RE: Palen Solar Power Project, Docket No. 09-AFC-7
Data Responses to January 7, 2010 CEC Workshop Queries
Data Responses to January 11, 2010 CEC Staff Email Queries
Attachment DR-CR-116a & b (Cultural Resources Impact Blocks)

**Palen Solar Power Project
Docket No. 09-AFC-7**

Data Response Queries – CEC Workshop, January 7, 2010

Data Response Queries – Request from CEC Staff, January 11, 2010

DR-CR-116a Plan View of Impact Blocks Disturbance Below Ground

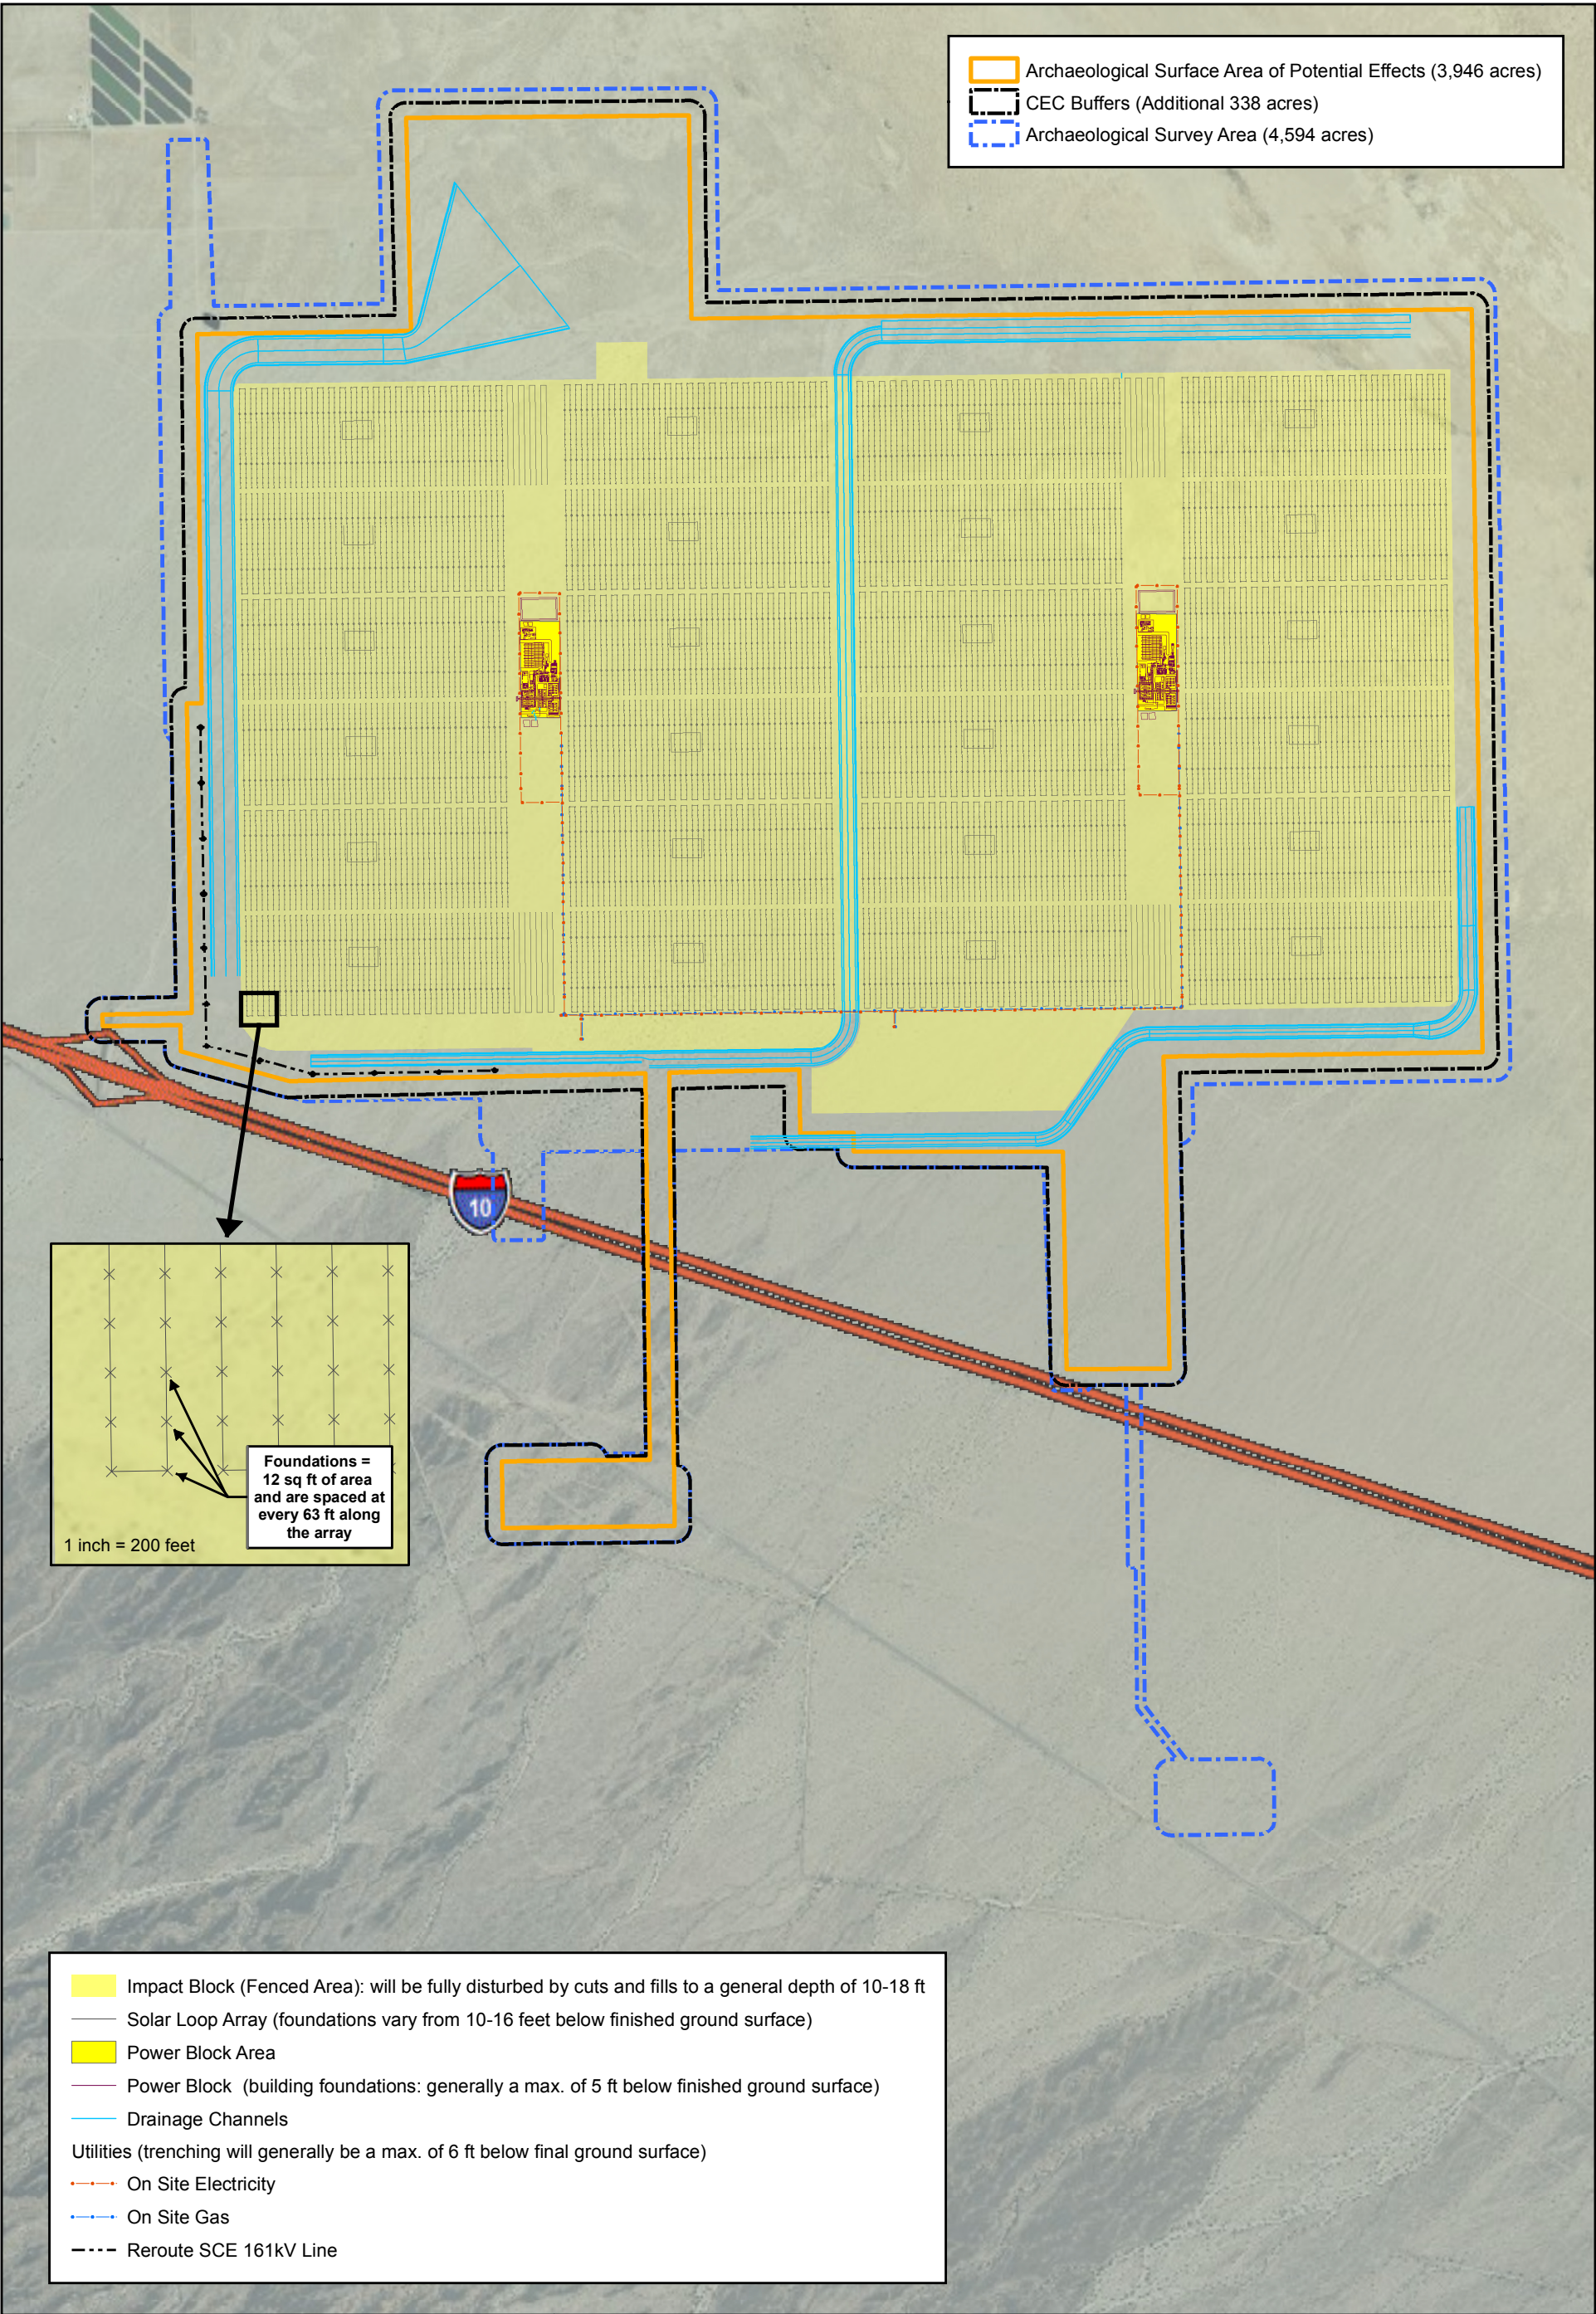
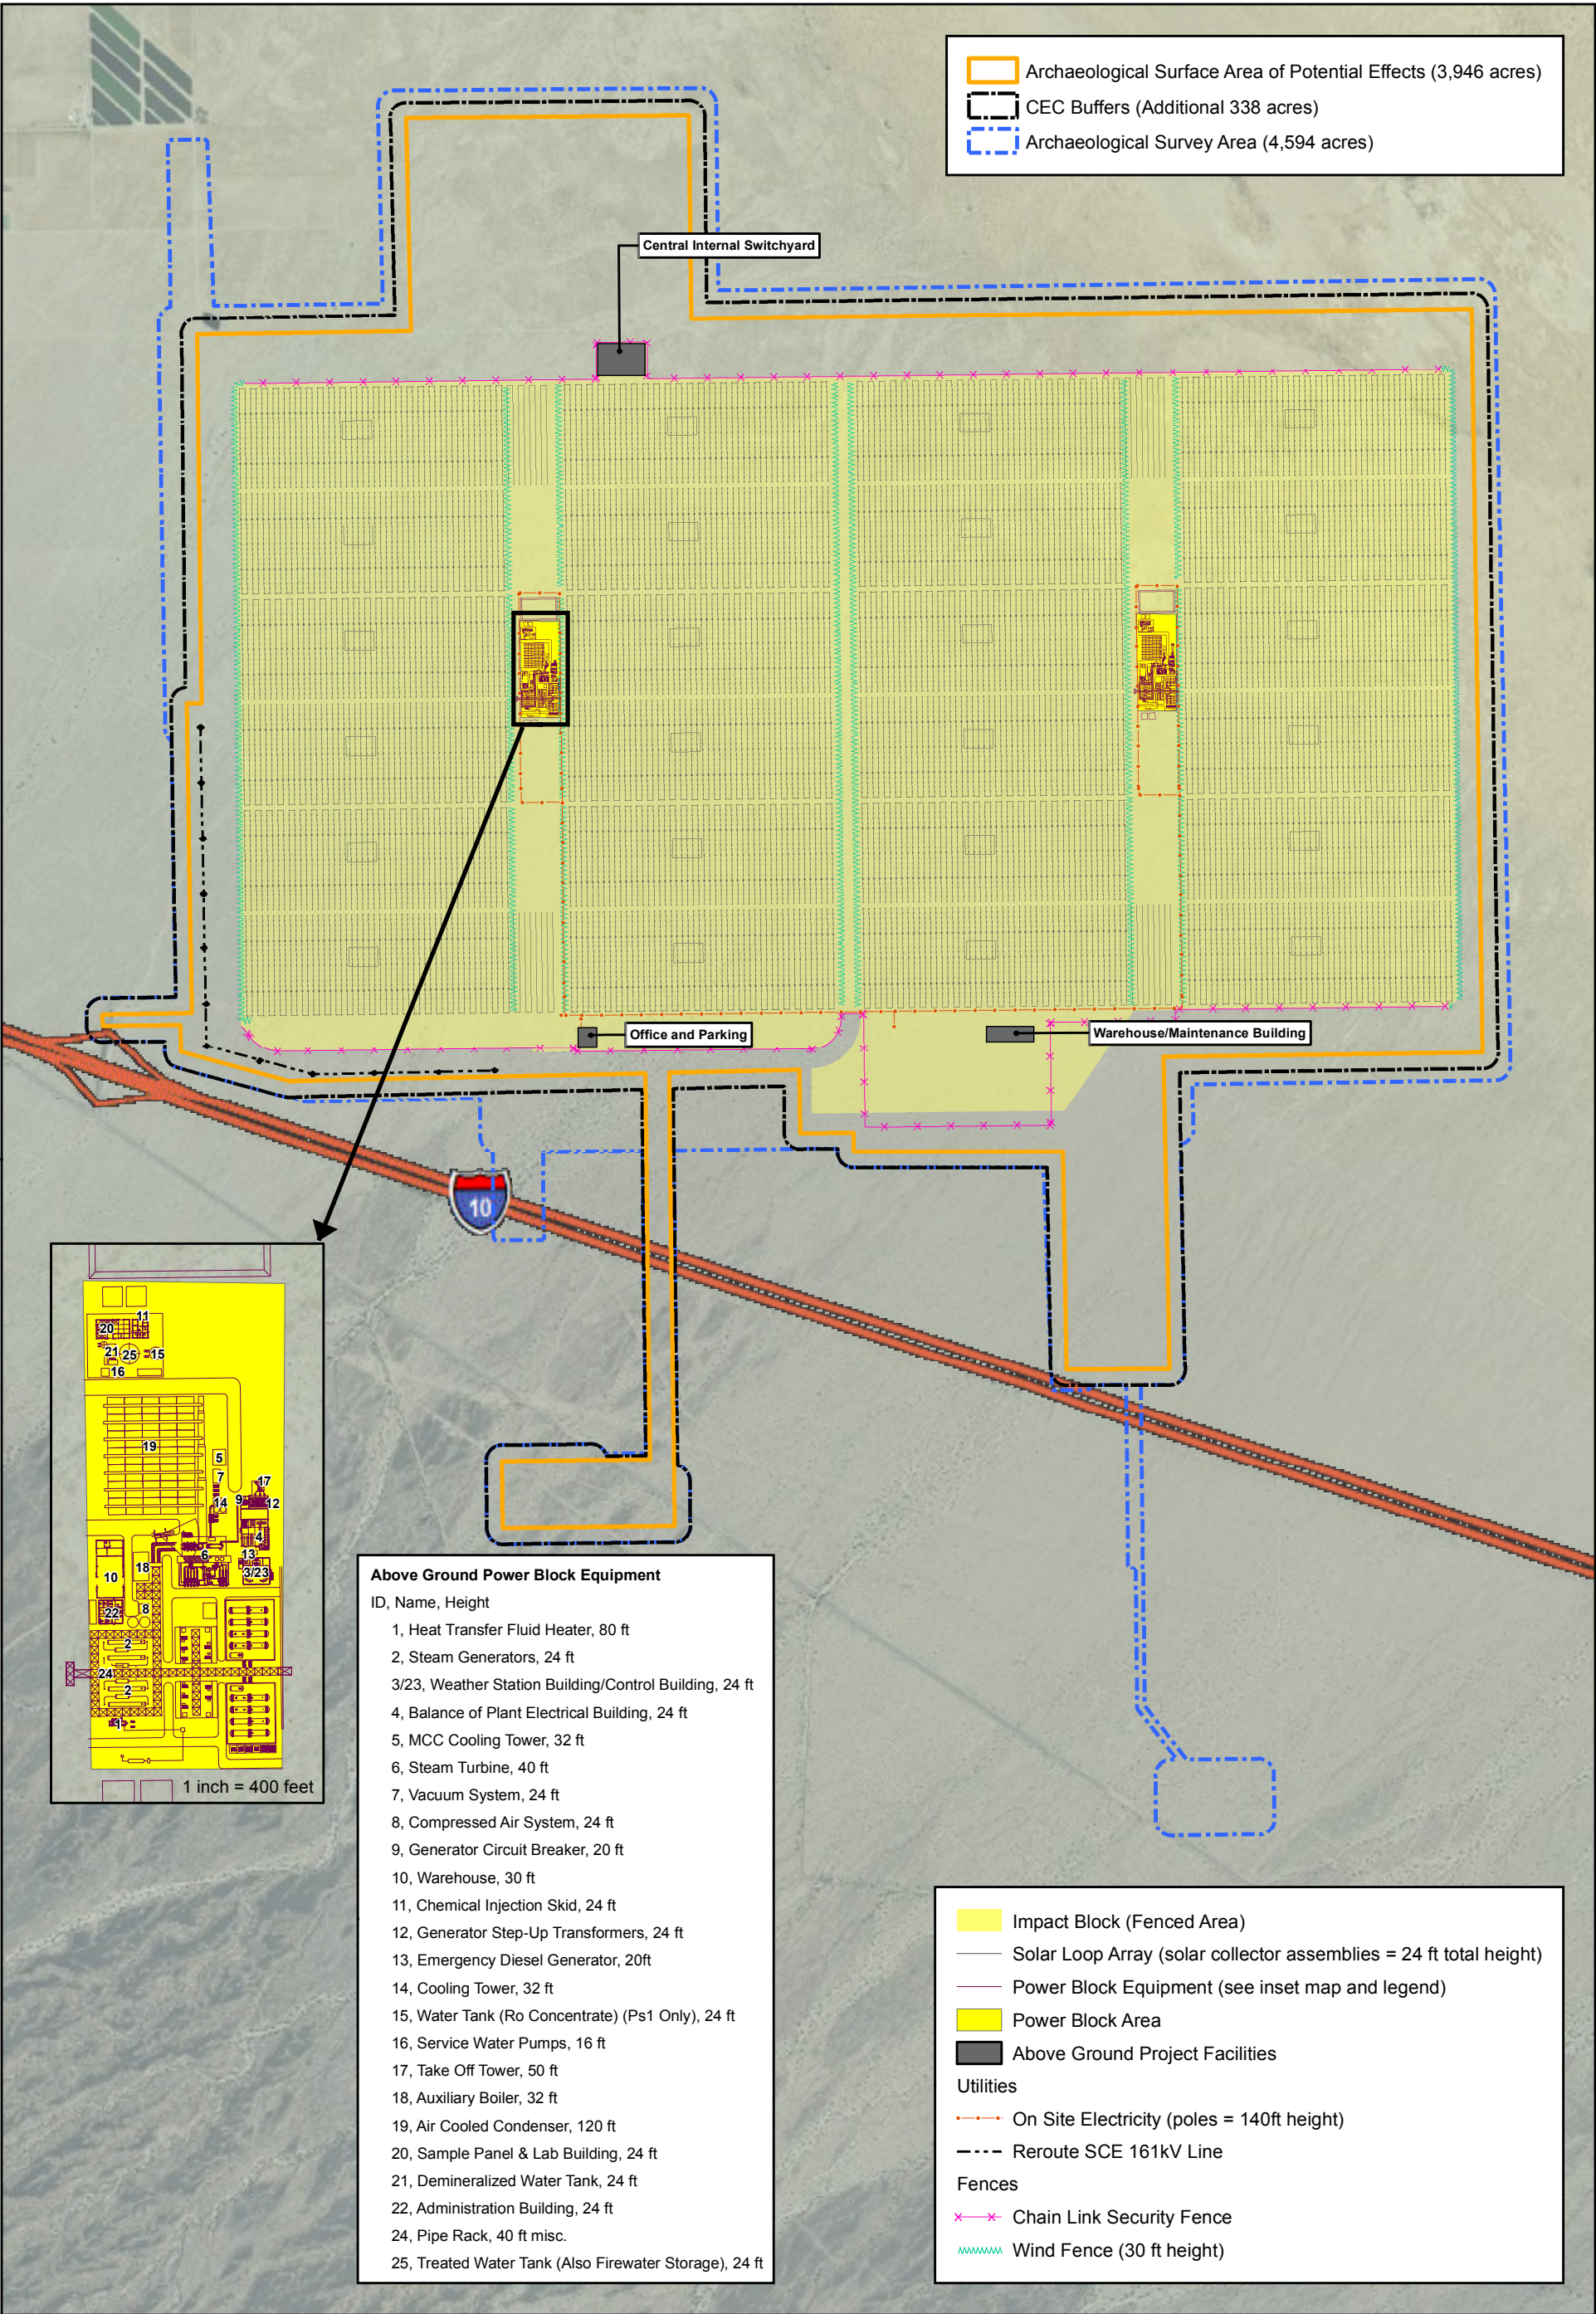
Please provide to staff a series of scaled and dimensioned plan-and profile views of the proposed project's (and alternative locations) impact blocks.

The plan view of impact blocks disturbance below ground and above ground are shown in Figures DR-CR-116a and b respectively on the following pages.
